666 71 Street DRB Presentation

Proposed Revisions 2.1.22

PROGRAM CHANGES

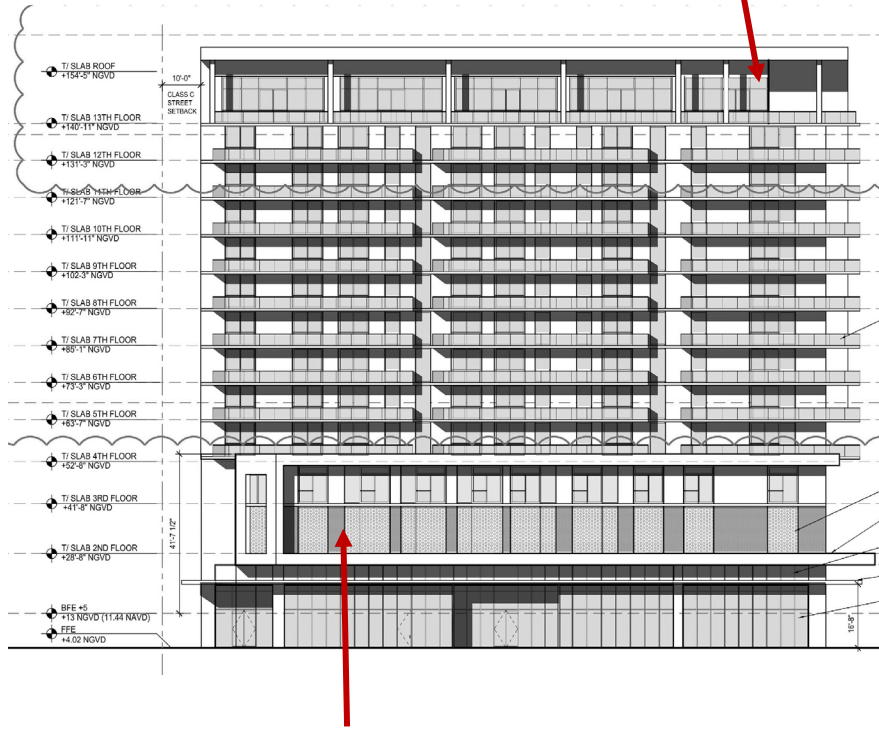
2.1.22 PROPOSED PLAN

126 UNITS

13 FLOORS / 154'

43 PARKING SPACES

ROOF TOP RESIDENTIAL

110 UNITS

13 FLOORS / 145'

67 PARKING SPACES

ROOF TOP RESTAURANT

71ST STREET NORTH ELEVATION

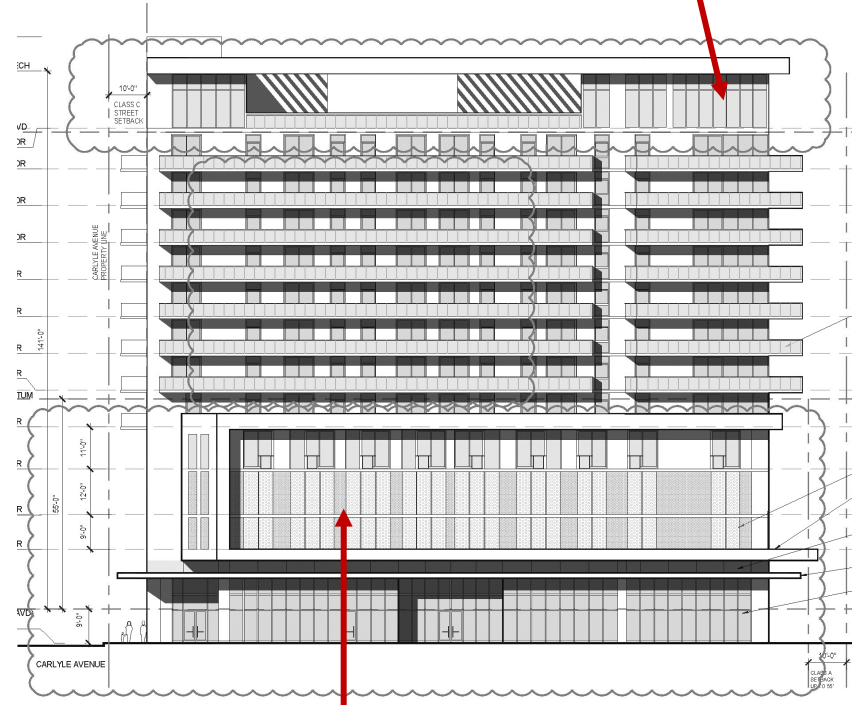
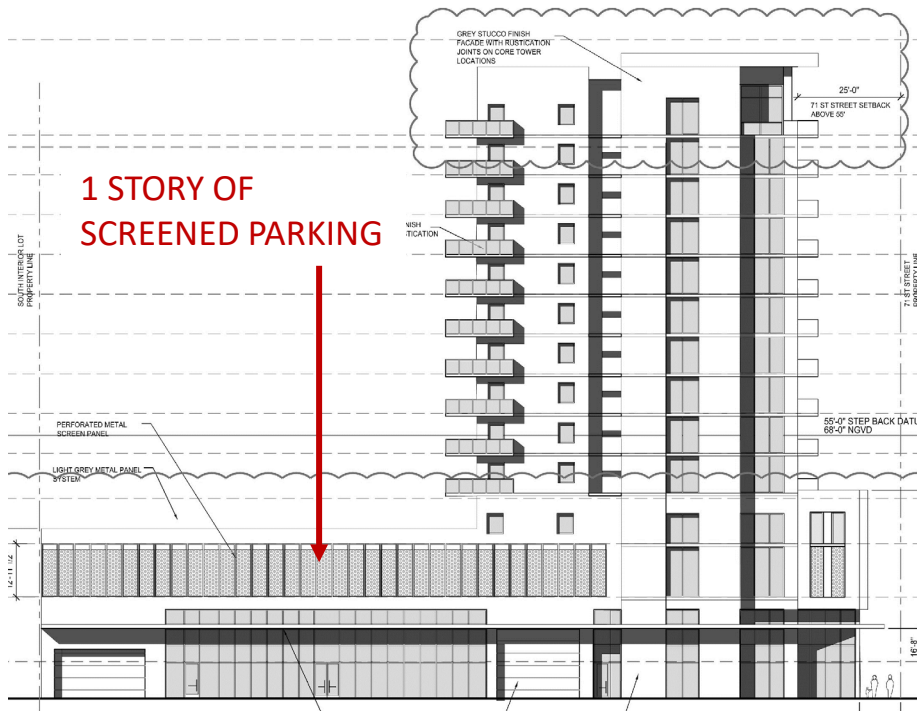
GLASS RECESSED

1 STORY OF
SCREENED PARKING

FLUSH GLASS LINE

2 STORIES OF
SCREENED PARKING

INDIAN CREEK DRIVE WEST ELEVATION

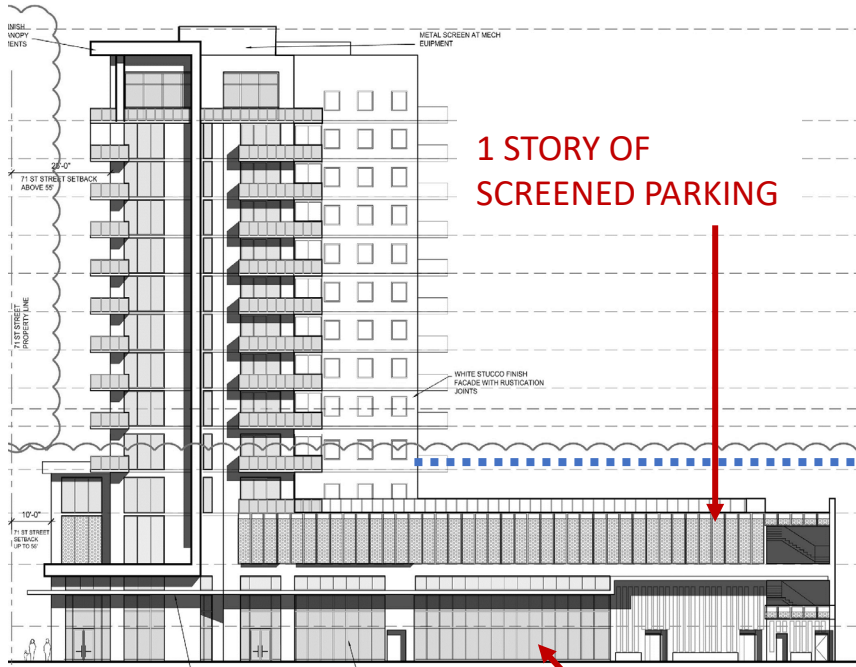
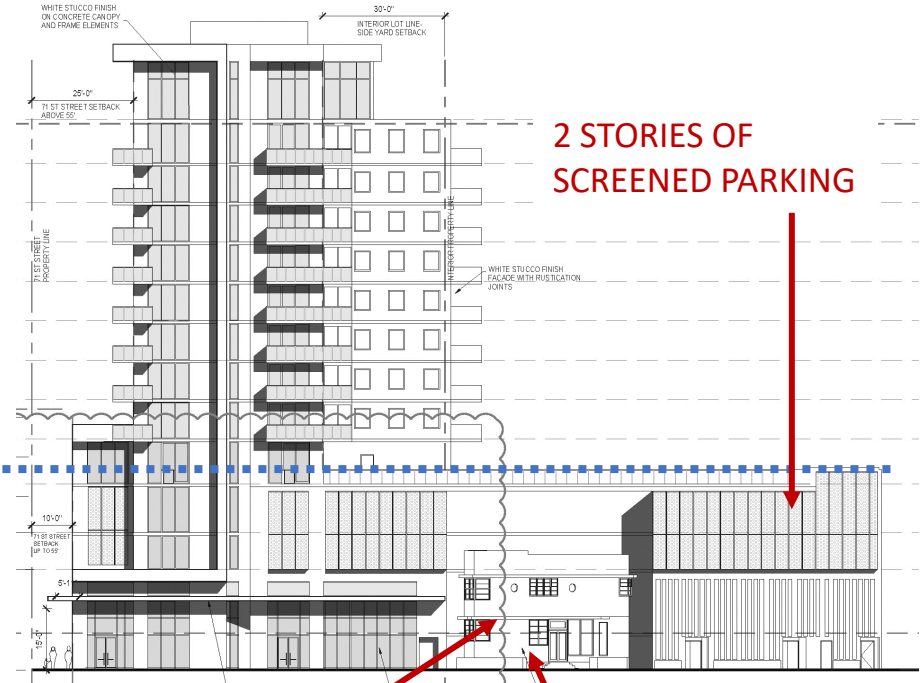
1 STORY OF
SCREENED PARKING

NEW RETAIL STOREFRONT
AND CONTINUITY OF
LANDSCAPE / SIDEWALK

2 STORIES OF
SCREENED PARKING

EXISTING 2 STORY
STRUCTURE

MASSING / DESIGN

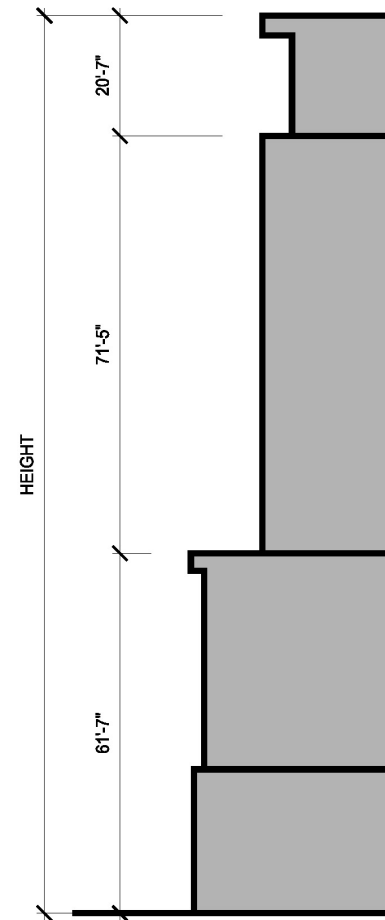
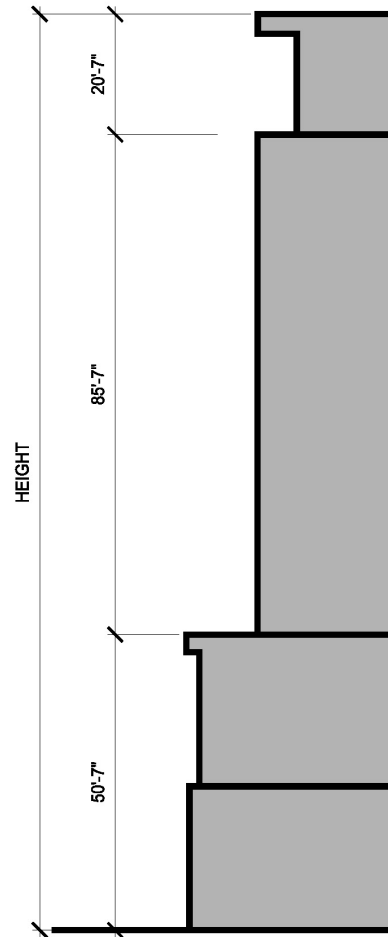
"FLYING WING"
FEATURE CANOPY
RE-ESTABLISHED

PROPORTIONS OF
BASE / TOWER / TOP

CONTINUITY OF
PODIUM AND
STREET SCAPE
